Notice of Modification

Project approval 09_0176 for the Ravensworth Operations Project, granted by the Minister for Planning on 11 February 2011.

Revised Conceptual Final Landform

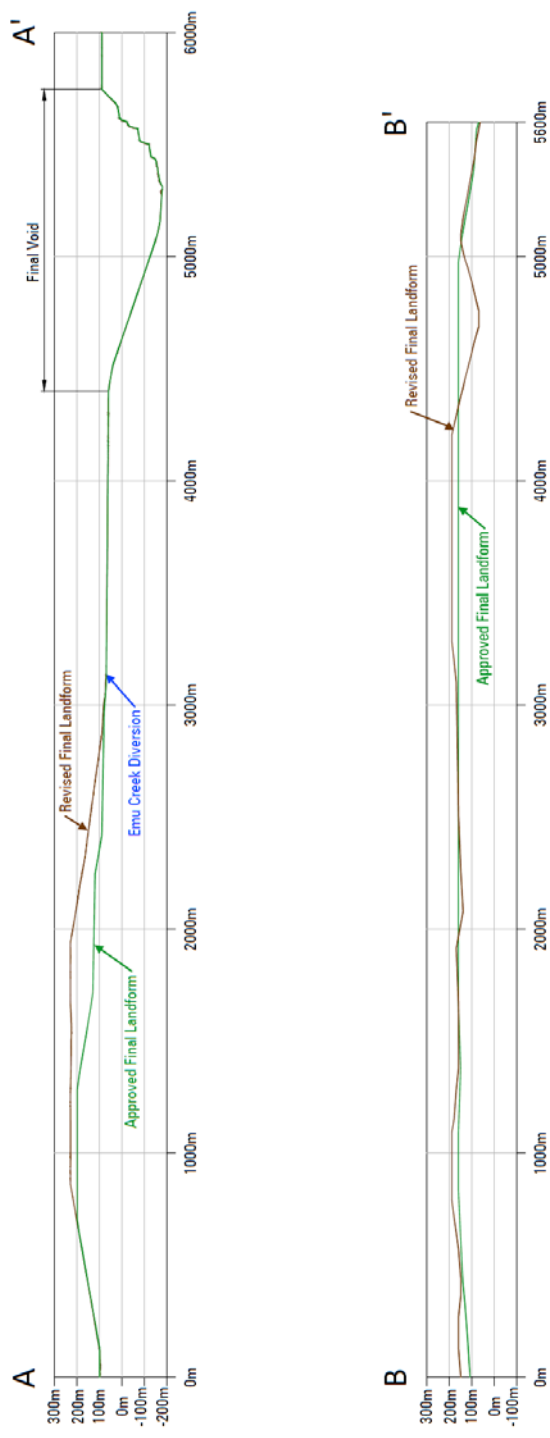
6. Insert the words "and Table 17 above" after the words "in the EA", in condition 41 of schedule 2.
7. Insert the following figures before the first figure in Appendix 7:

(The indicative landform indicated is to be further developed at detailed design to ensure appropriate natural looking micro relief.)
